Consultant	Wahib Medanat Consultant Engineers	Rep No.	
Site Name	Um Al Dananir Basic Mixed - Balqa	Date	
Package	Package 1		
Contractor	Derar Saraireh & Sons for Engineering & Contracting		
Tender No.	1/2020/USAID/SKEP/3/1

o. QC-11 11 7 / 09 / 2021

Irregularity in the formwork of the slab

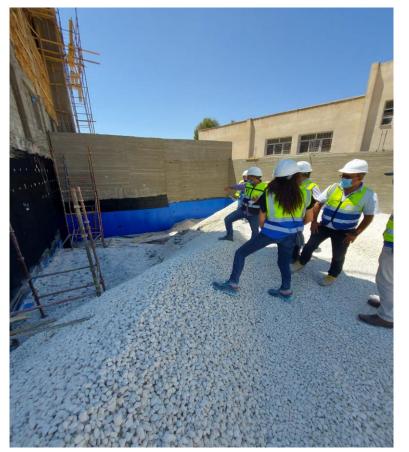
Description of Non Conformance	Corrective Action	Required by / When
 Irrigularity of formwork in some area caused the same observed after removing formwork. Wooden pieces observed remaining at the newly casted roofs after removing formwork. Protection of waterproofing sheets for external walls should be completed before starting the backfilling work. 	plastering layer, should be done taking care regarding the thickness limit mesh may be used. 2. To be removed before plastering.	The Contractor/Immediately
Dana di Dana ang di kas	Hassan Shaqbua, Supervision
